# **Objection to Planning Application 2024/1364/P**

NCP Saffron Hill 14 St Cross Street

## **8.1 The Ziggurat, 60-66 Saffron Hill, EC1N 8QX**

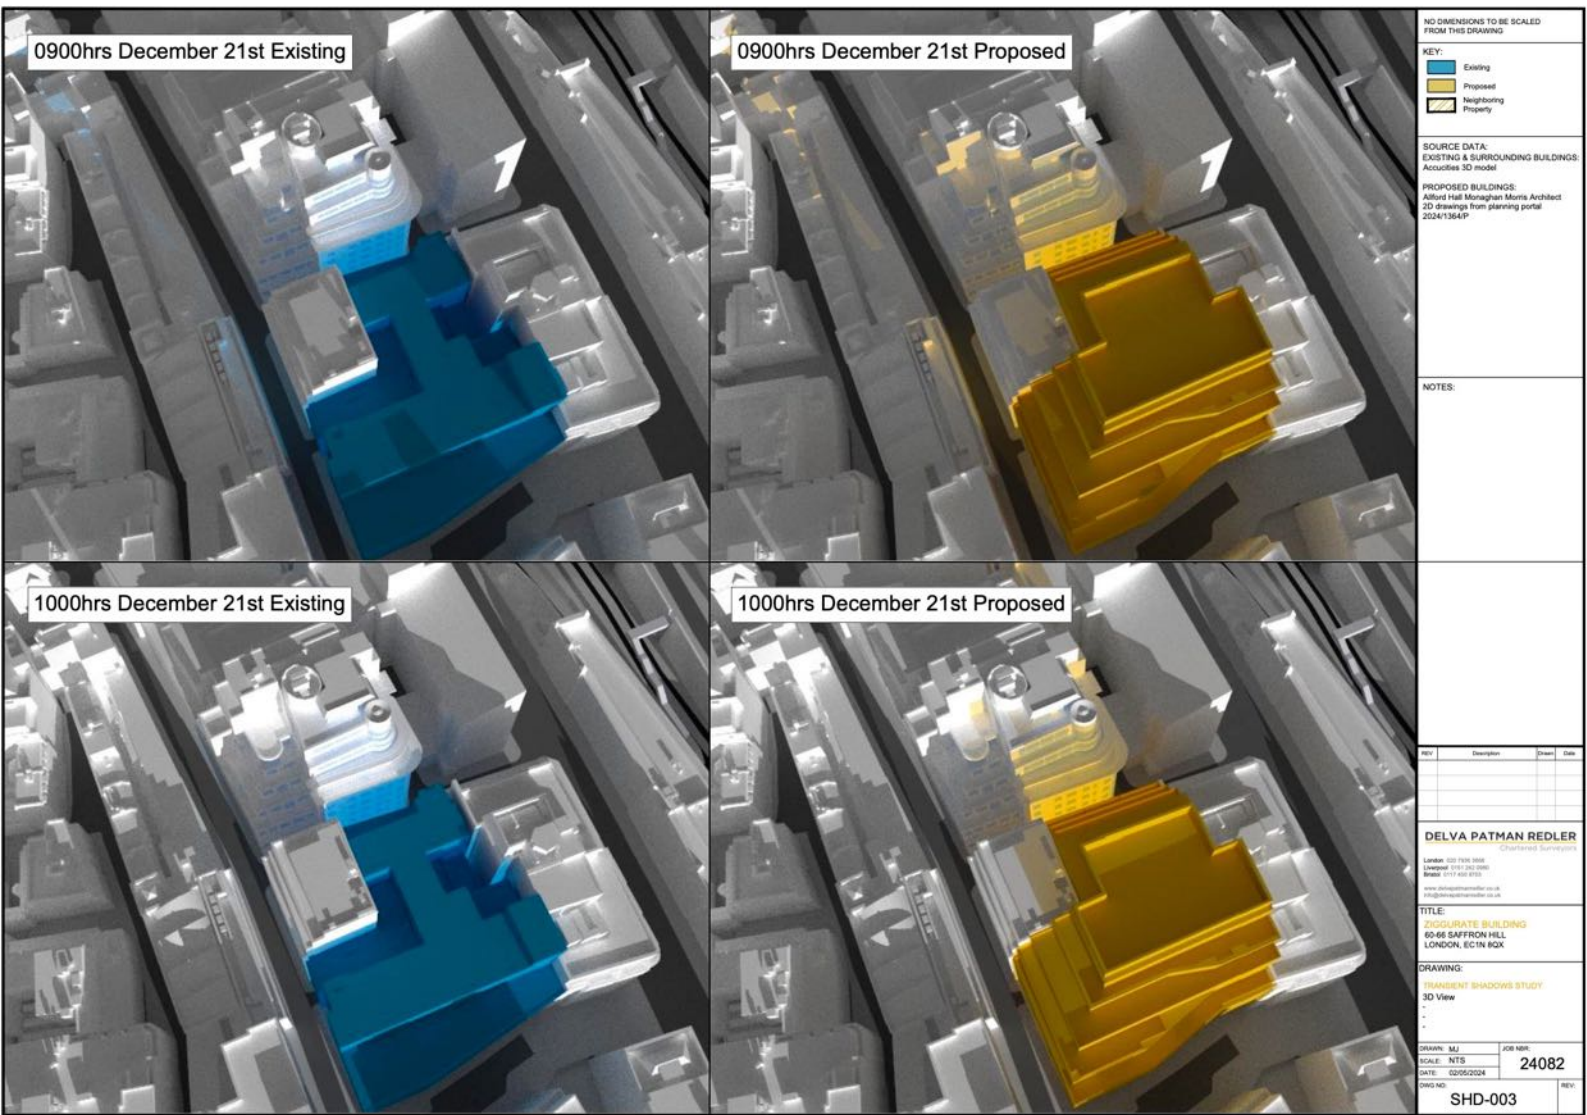
This statement isn’t true. The Daylight & Sun path report below commissioned by Ziggurat Freehold Ltd demonstrates that during the winter months, the sunlight to our amenity including rooms and terraces will be entirely blocked for the whole morning period.

This Transient Shadow Study was commissioned by Ziggurat Freehold Ltd to model the loss of daylight and sunlight on the south facing floors of our building. It compares the existing car park in blue with the proposed new building in yellow. This example modelled on the 21<sup>st</sup> December would put our facade in shadow through the winter from October right through to the end of March.

#### Incorrectly named Ziggurat levels in all the 4.0 Architectural Design Stakeholder Engagement Plans & Townscape Strategy Plans

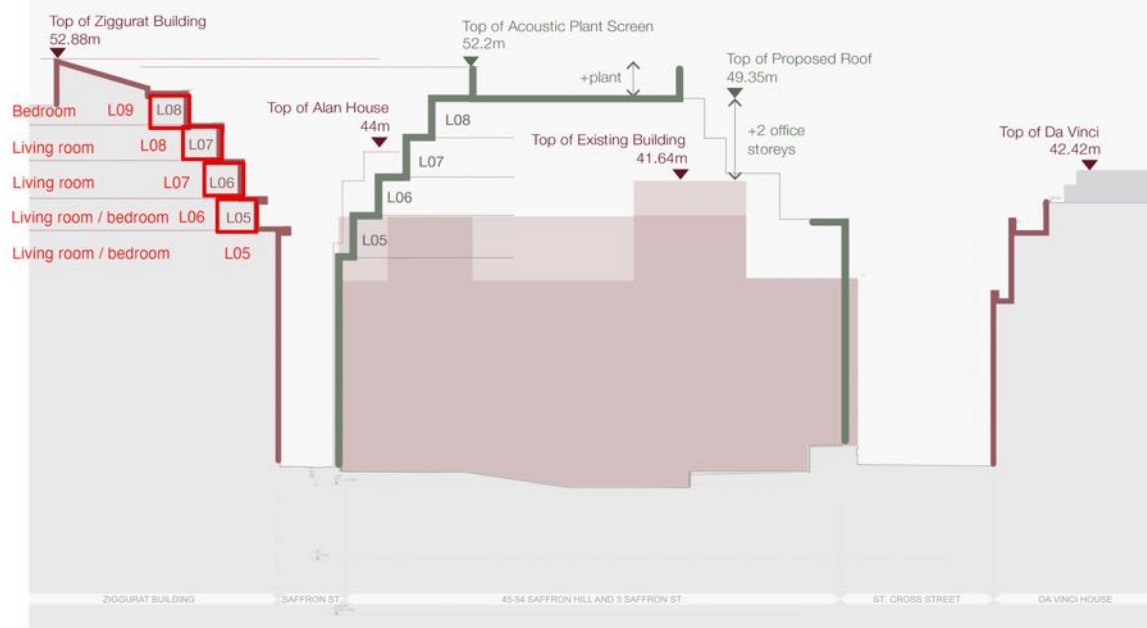
We'd also like to draw to your attention to the 4.0 Architectural Design 4.18 Stakeholder Engagement height explanations. The Ziggurat levels have all been incorrectly labelled from pages 139 – 153 in the DAS report. Level L08 is in fact L09 on the ninth floor down to L05 which is labelled L06. In the 4.18 2. Review of enclosure and relationship with neighbours, the LG level is sited well above ground.

As all the floor levels on the Ziggurat have been incorrectly labelled, it gives a false representation of the height relationship between the two buildings.

Dwg No: P3173/WM/01

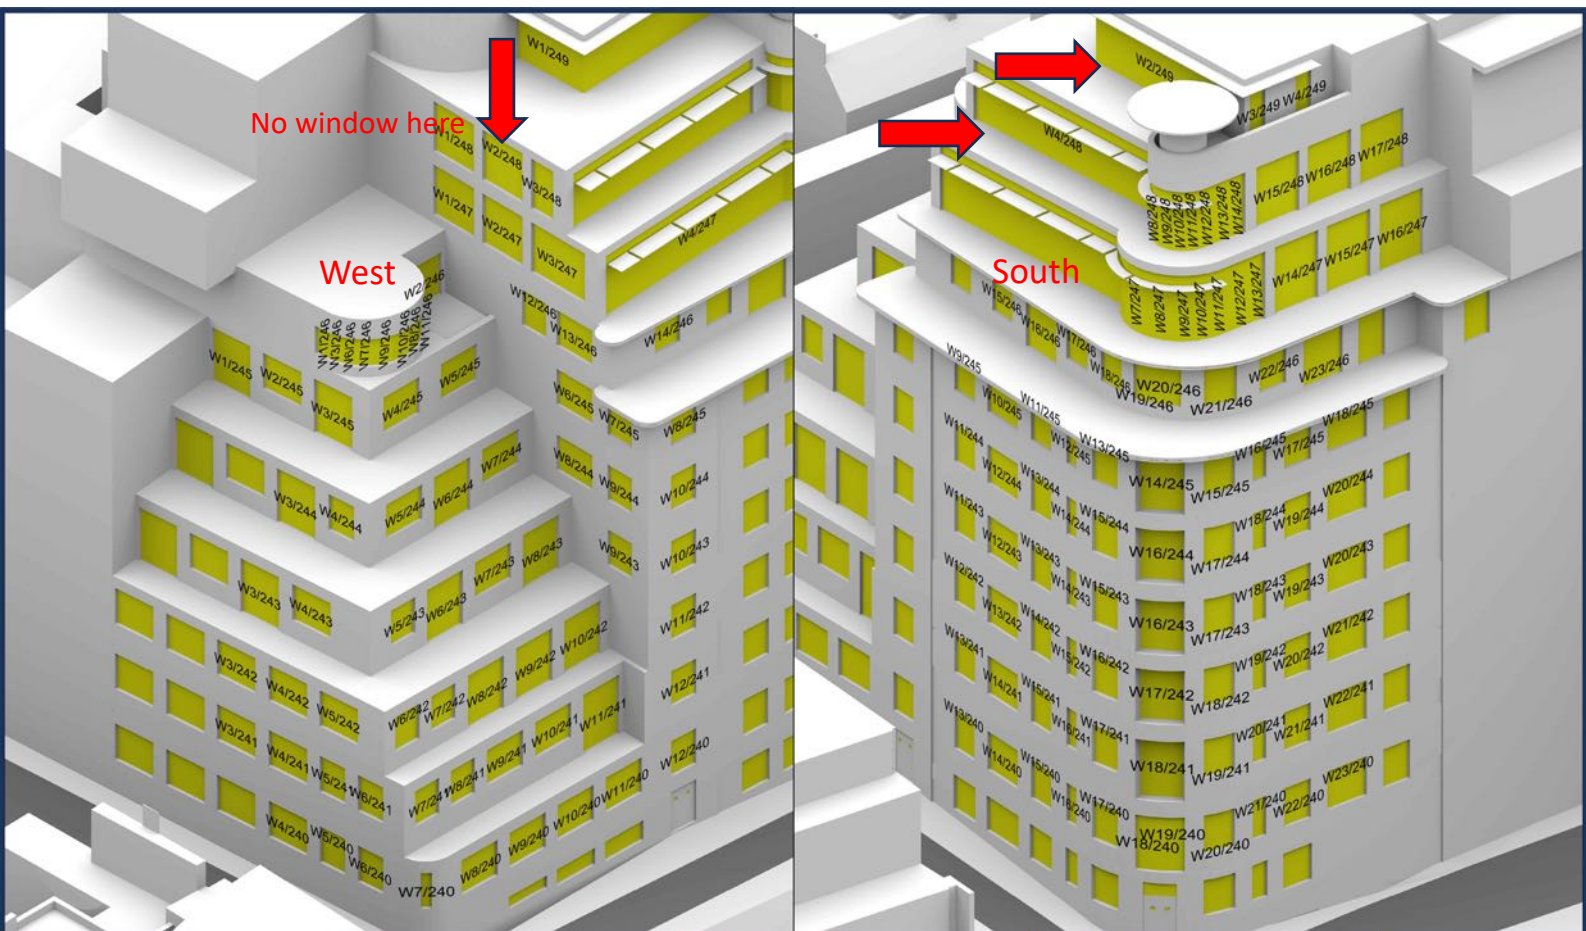
In the Right of Light Contours P3173/WM/01, the south facing elevation below has no identifiable window position numbers attached to the 7<sup>th</sup>, 8<sup>th</sup> and 9<sup>th</sup> floors although the evaluations are set out in the tables. Why aren't the W4/248-W7/248 windows identified? This is a living room not studio with bedroom above.

Contextual Daylight Study Part 2  
P3173/FS/1 below, sites a derelict 3 storey building with a tower block blocking its SE aspect.

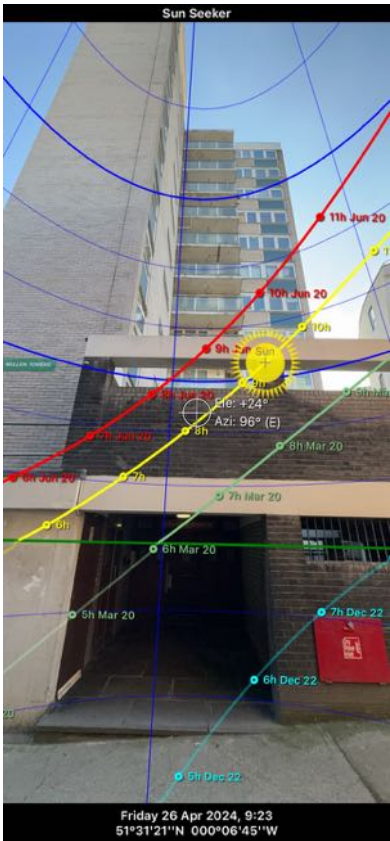
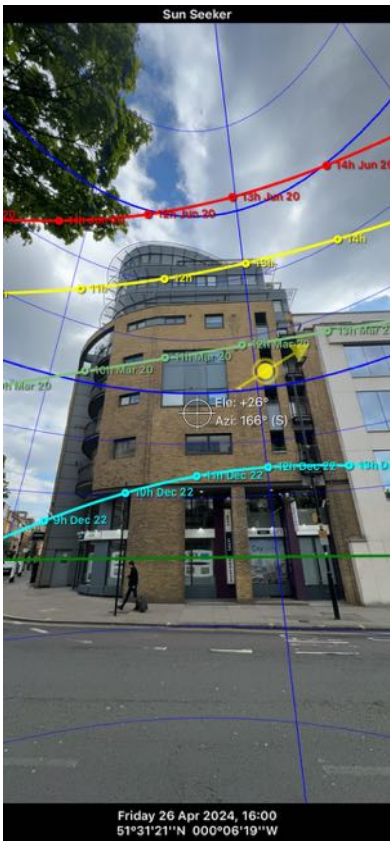
P3173/FS/1 sites a derelict 3 storey building with a tower block blocking its SE aspect.

Actual building modelled is Panther House, Mount Pleasant 99° SE

Tower block blocking the SE aspect to Panther House, Mount Pleasant 276° W

Contextual Daylight Study Part 2 analysis undertaken by Point 2.  
Incorrectly named – this is Millennium Heights, Britton Street not Clerkenwell Road.  
Inaccessible lightwell behind the building not the facade on Clerkenwell Road. See map below.

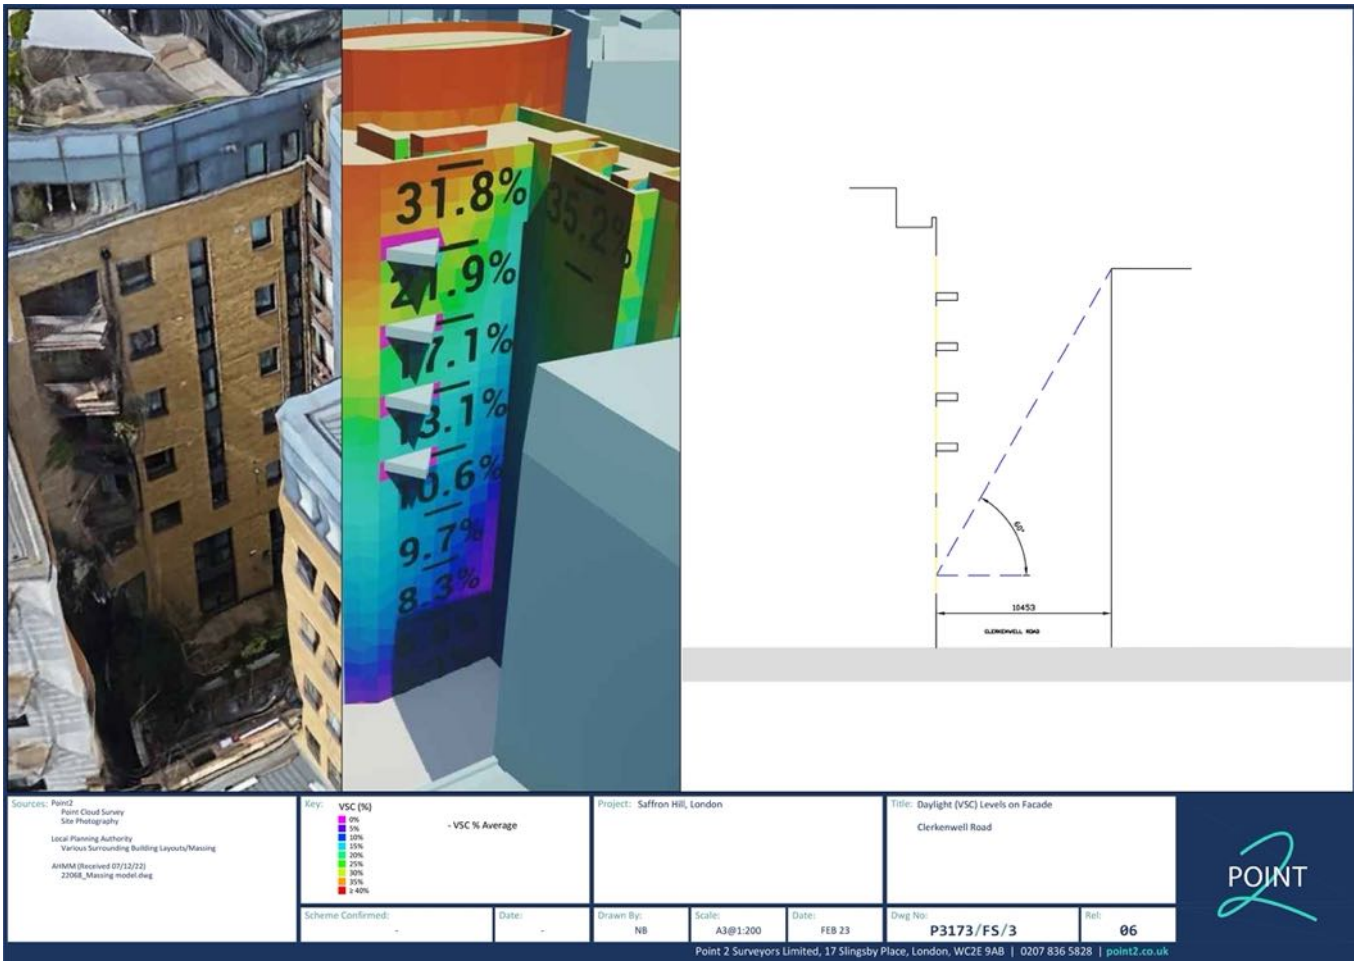
P3173/FS/3 uses an inaccessible lightwell.

Actual site  
Millennium Heights,  
inaccessible internal  
lightwell used  
instead of facade

Buildings that bear no relationship in size and aspect to the 9 storey 180° south facing Ziggurat Building.  
P3173/FS/4 sites a 3 storey building with a NE facade.

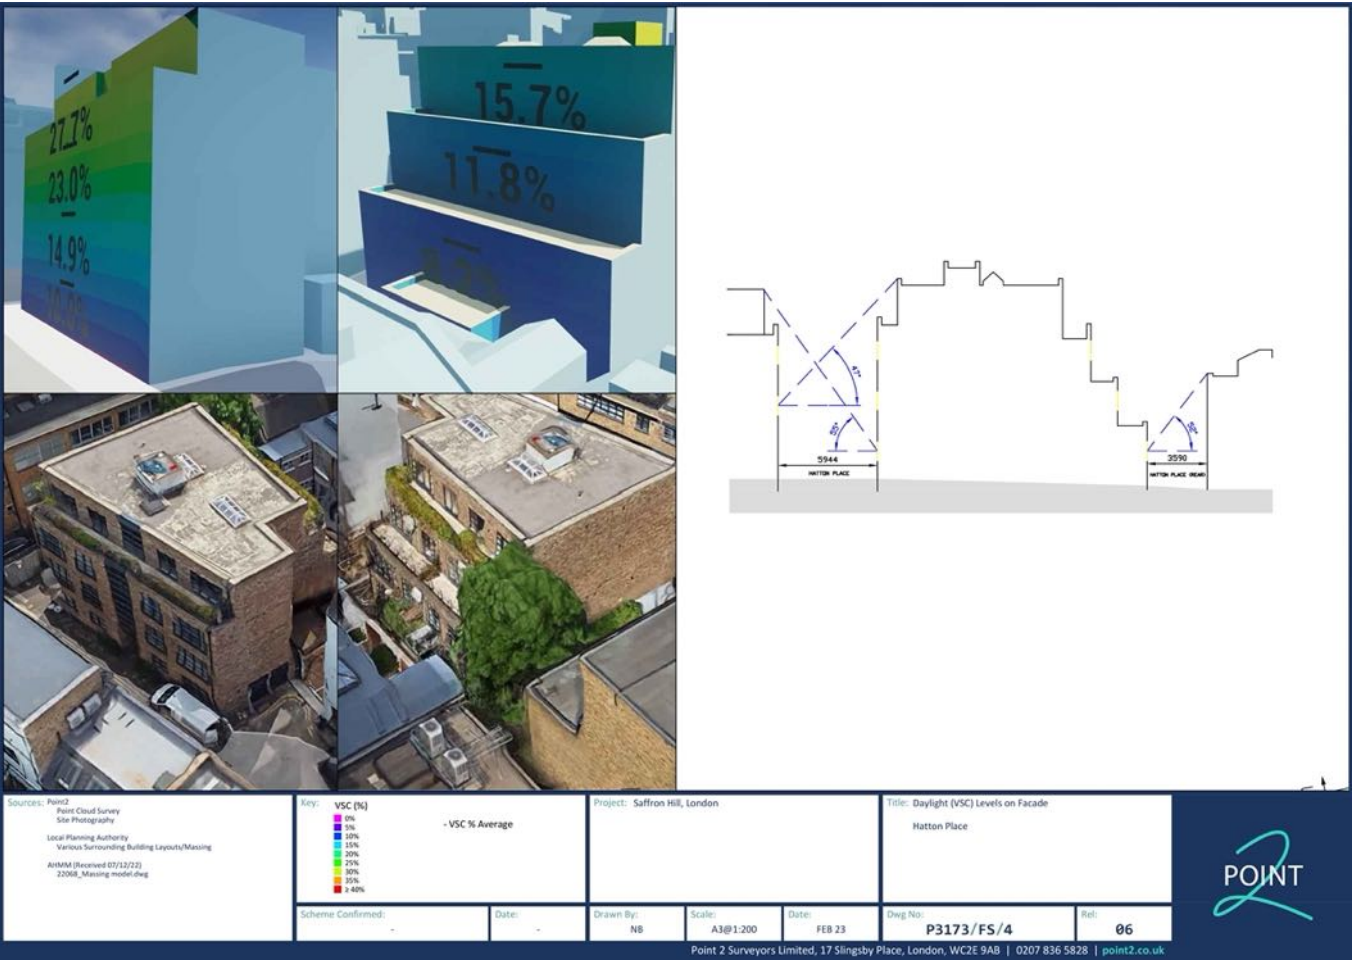
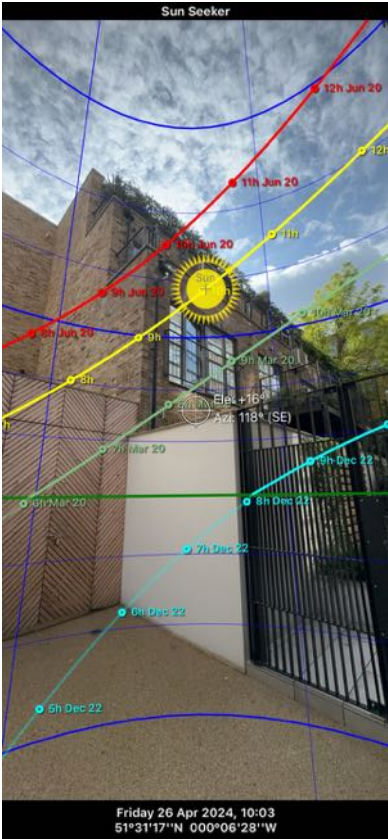
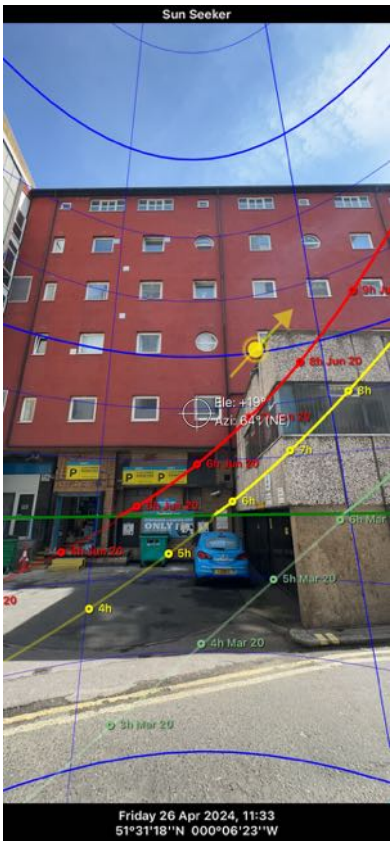
P3173/FS/4 uses a 3 storey NE facing building.

17 Hatton Place  
Facade of 3 storey  
building  
56° NE

Contextual Daylight Study Part 2  
P3173/FS/8 below, misnamed Clerkenwell Road is the rear of the Montgomery Building from Onslow Street. The east facing, 9 storey facade of the Ziggurat is used as the comparator.

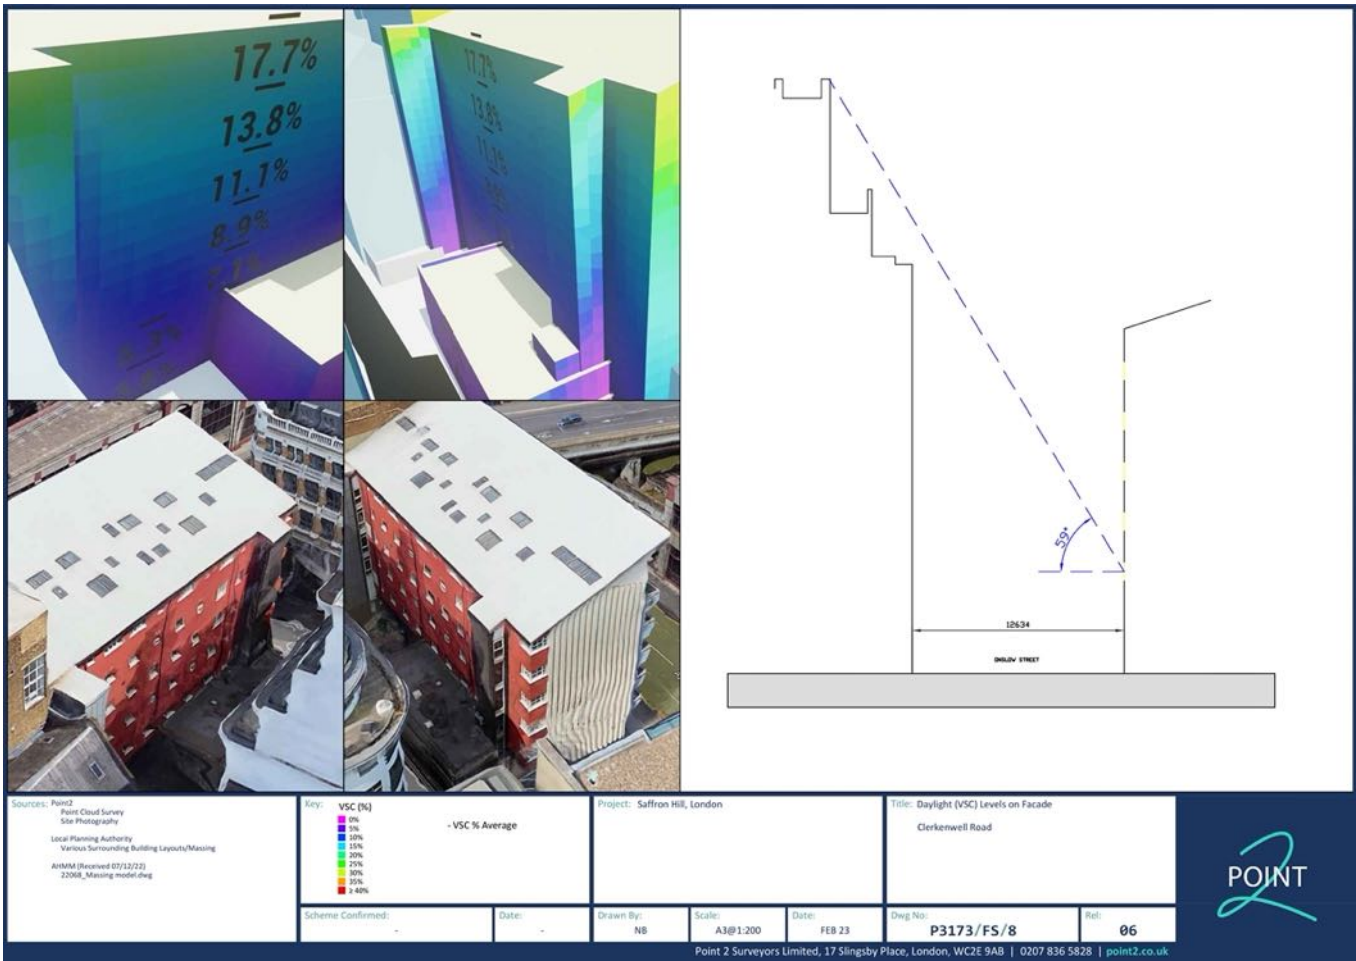
P3173/FS/8 the Montgomery Building in Onslow Street is referenced against our larger, east facing facade.
